**LEGAL ADVERTISEMENT  
PORTLAND PLANNING BOARD  
MEETING AGENDA**

**To:** Chair Boepple and Members of the Portland Planning Board  
**From:** Matthew Grooms, Planner  
**Date:** October 5, 2017  
**Re:** Brandy Lane Subdivision (Sixteen Lots), 22 Hope Lane  
LBW, LLC  
Preliminary Review  
**Project #:** 2017-117 **CBL:** 448-A-004  
**Meeting Date:** October 10, 2017

RE: Staff Review Comments for Brandy Lane Subdivision (2017-117) – Planning Board Review

**TO:** Matt Grooms, Planner  
**FROM:** Lauren Swett, PE & Craig Sweet, EIT  
**DATE:** September 14, 2017  
**RE:** Brandy Lane, Subdivision Application

Drawing No.  
**C103**

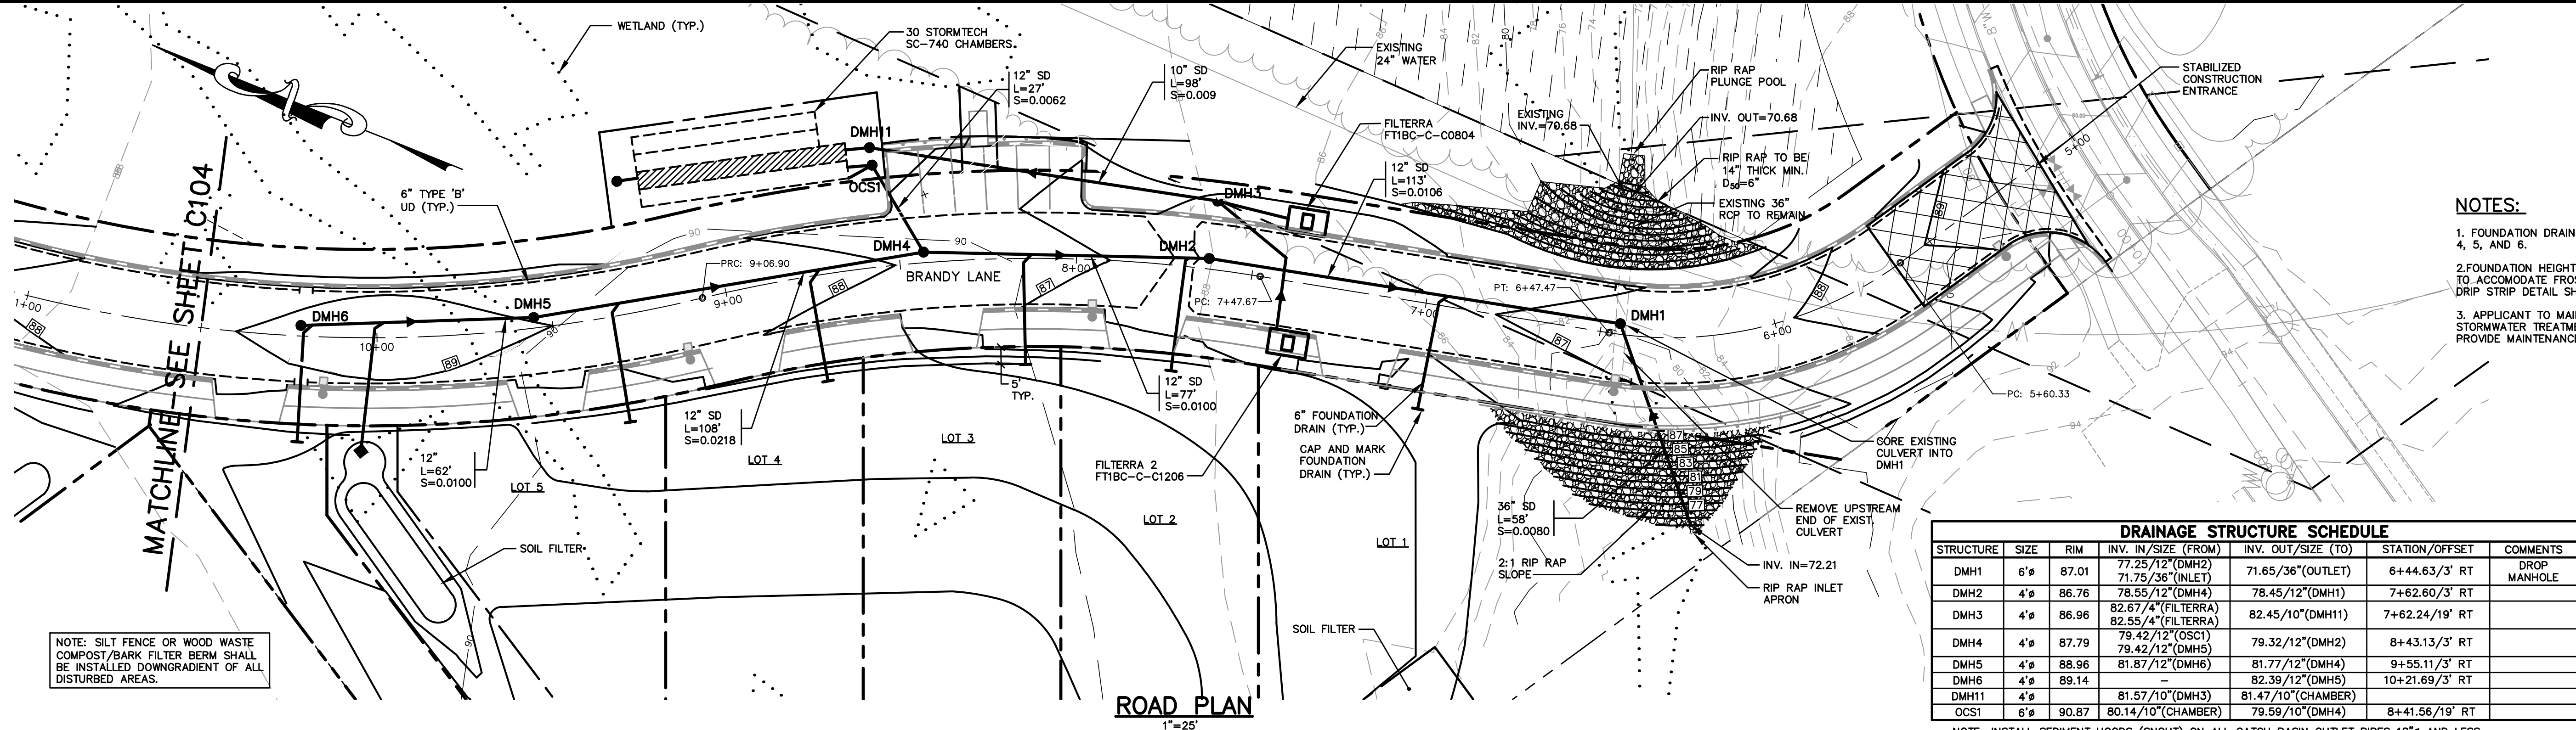
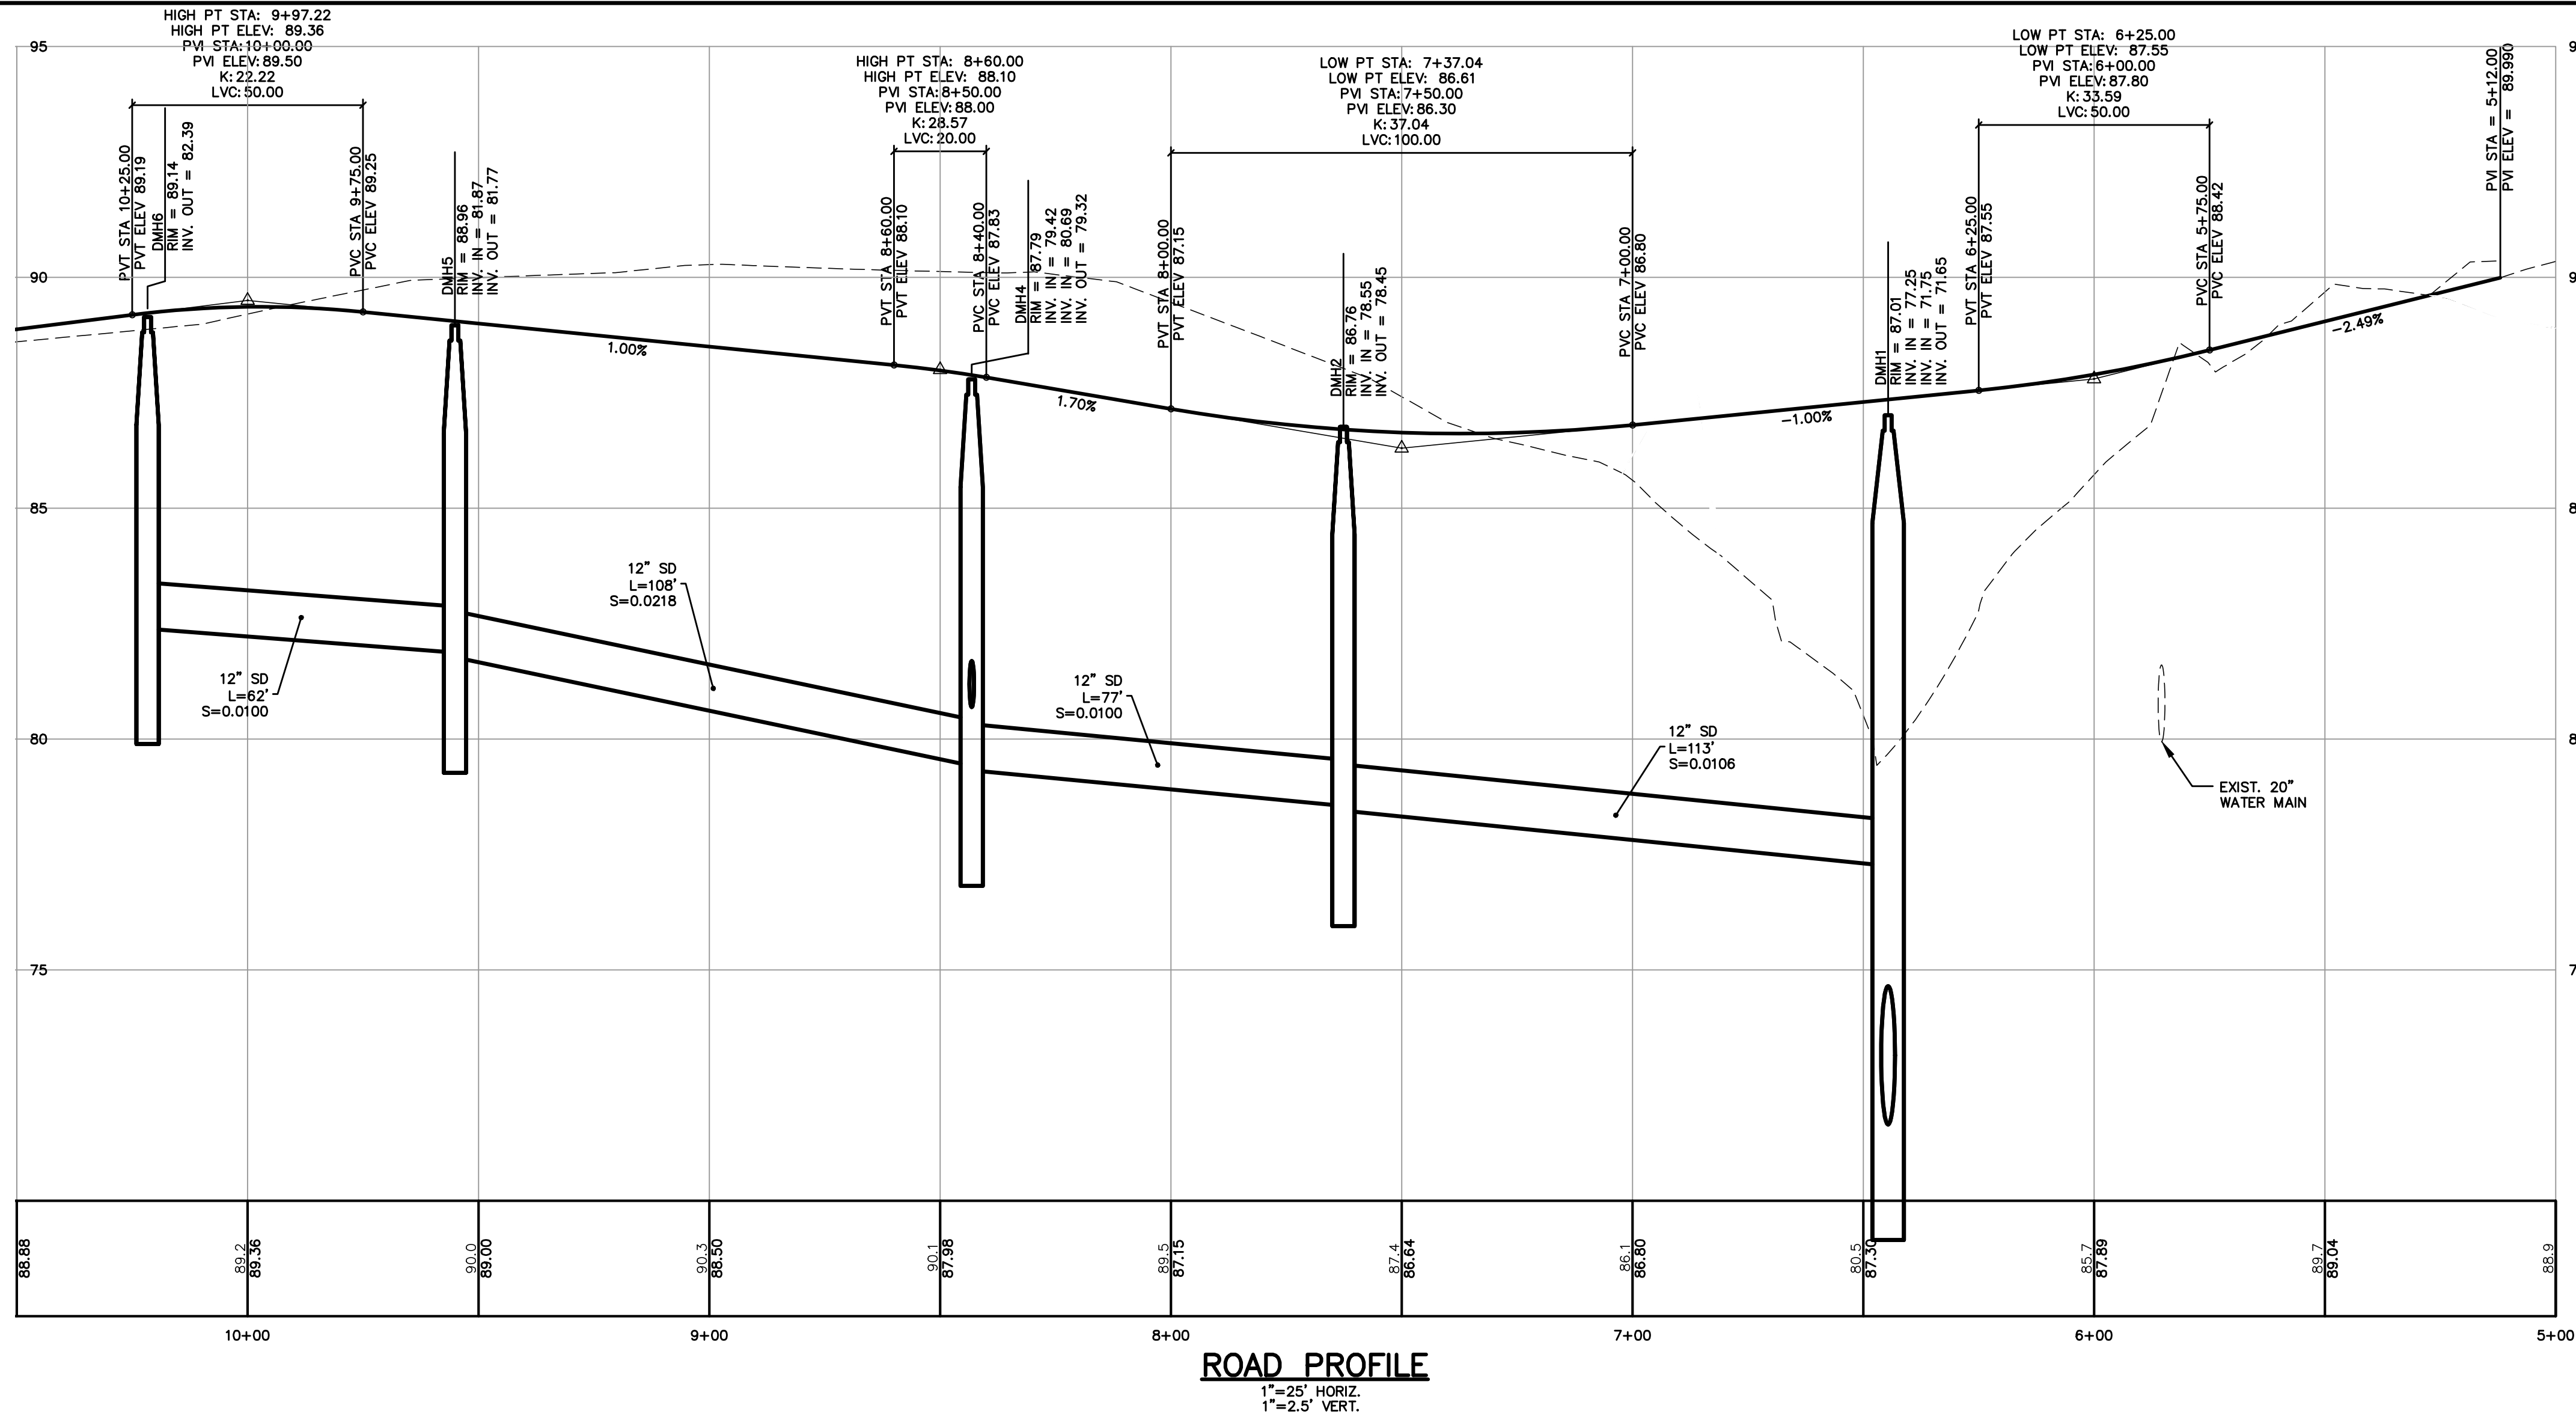
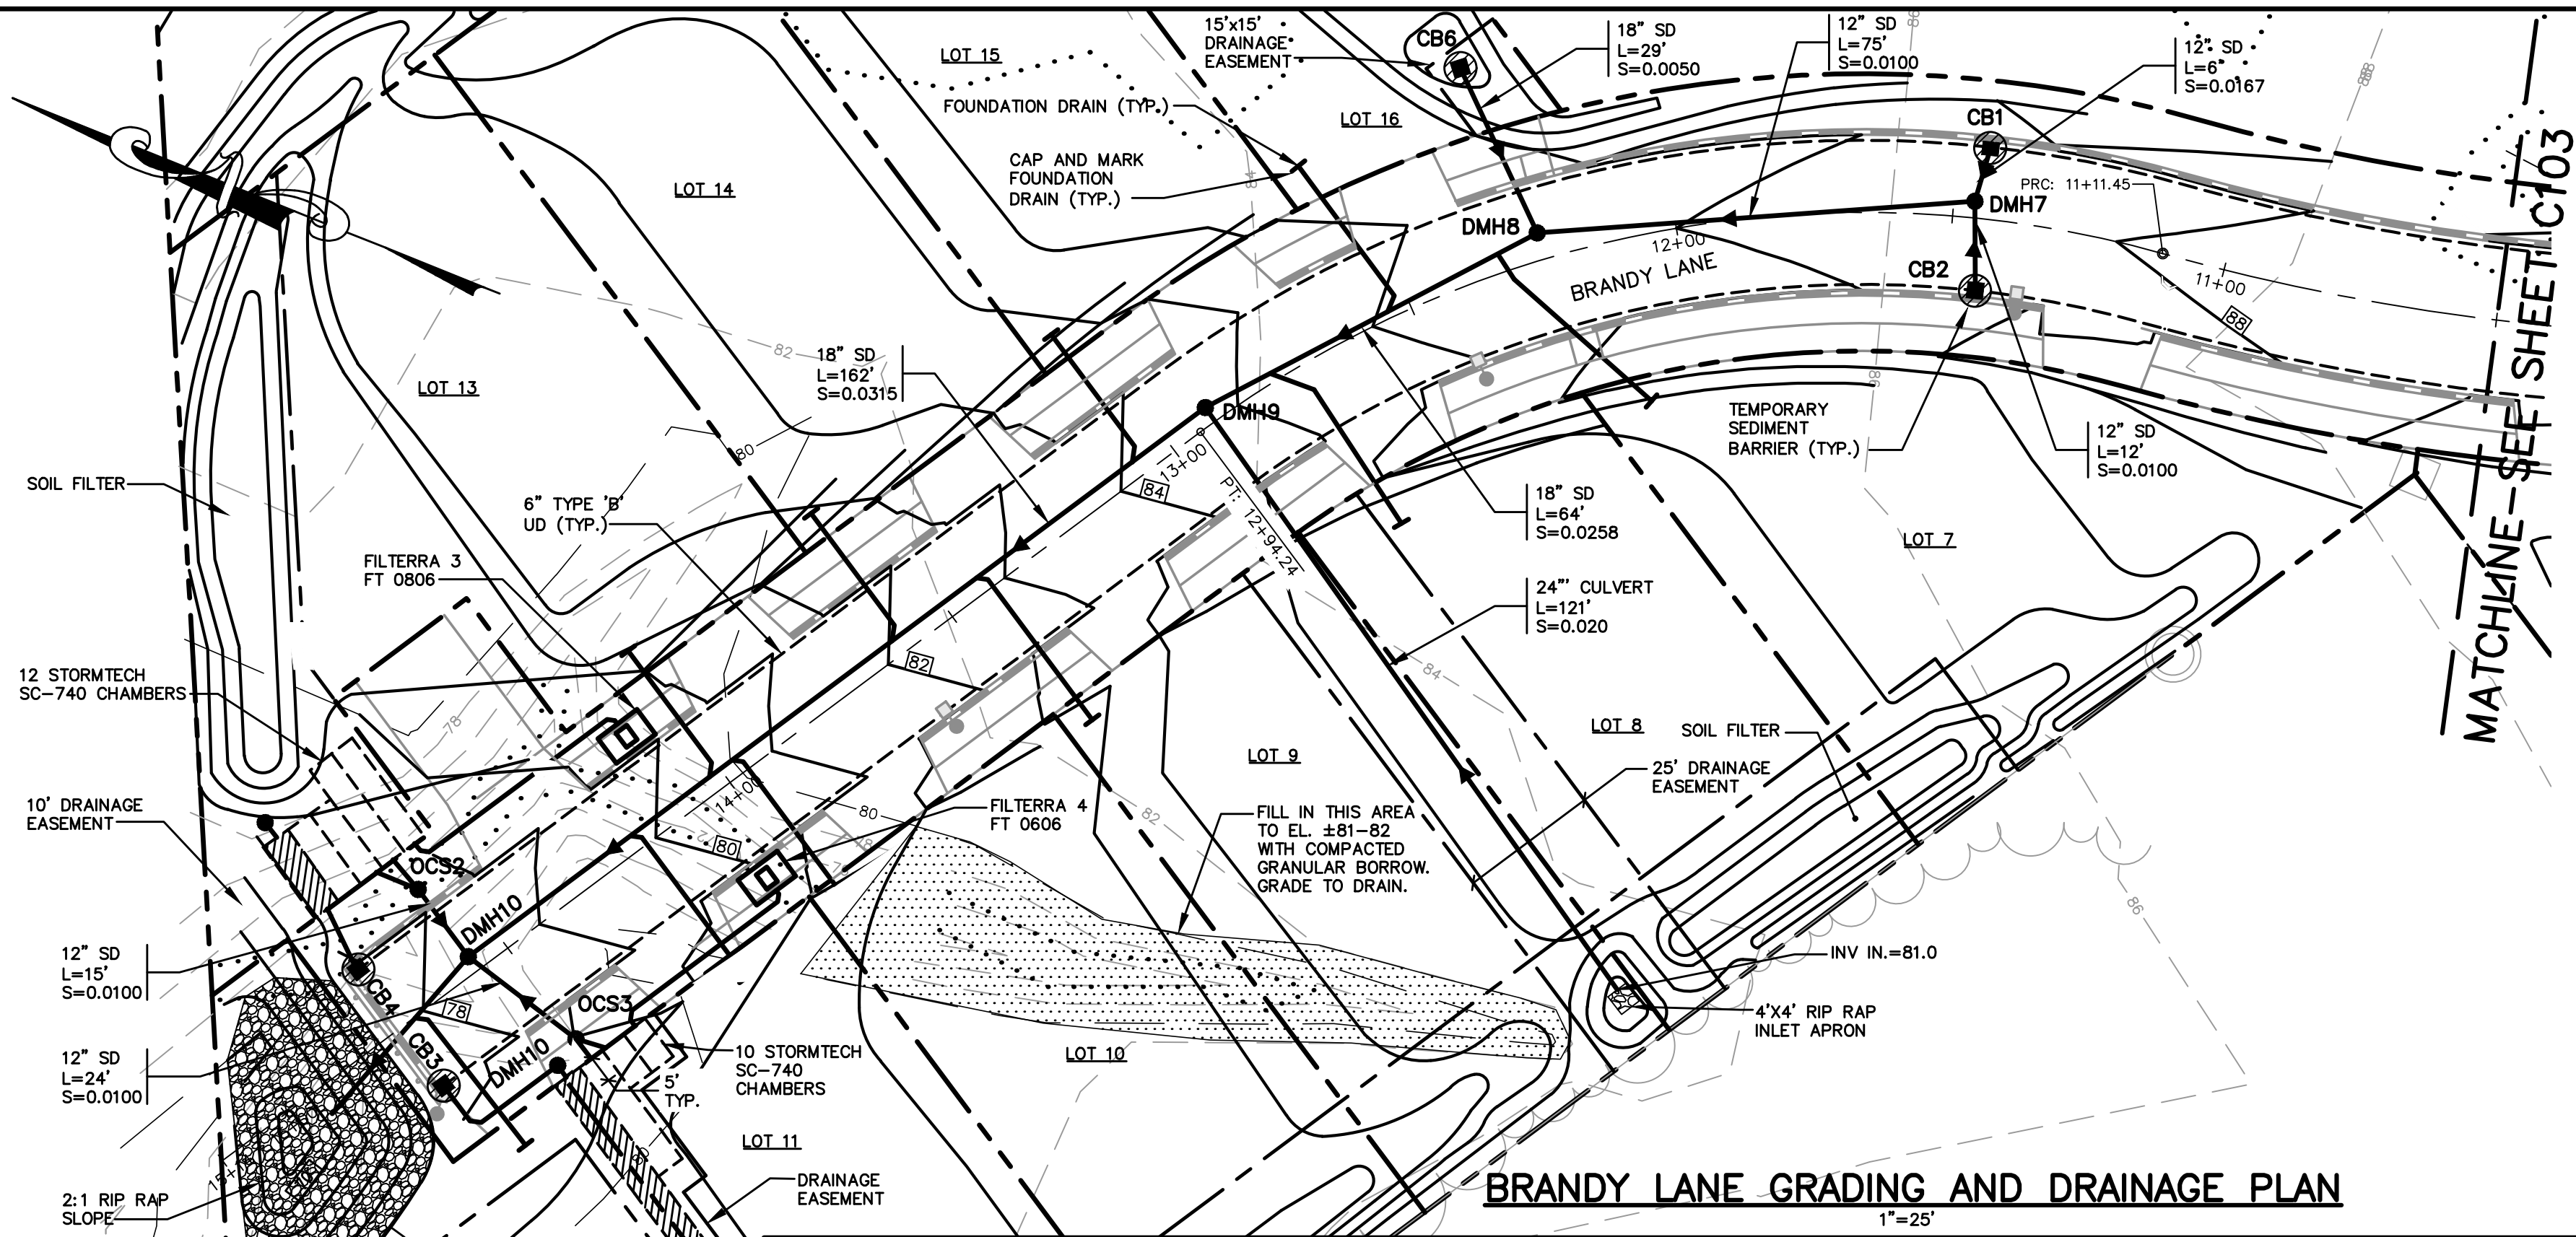
**Sheet C103, C104 & C105:**

#### Sheet C103, C104 & C105
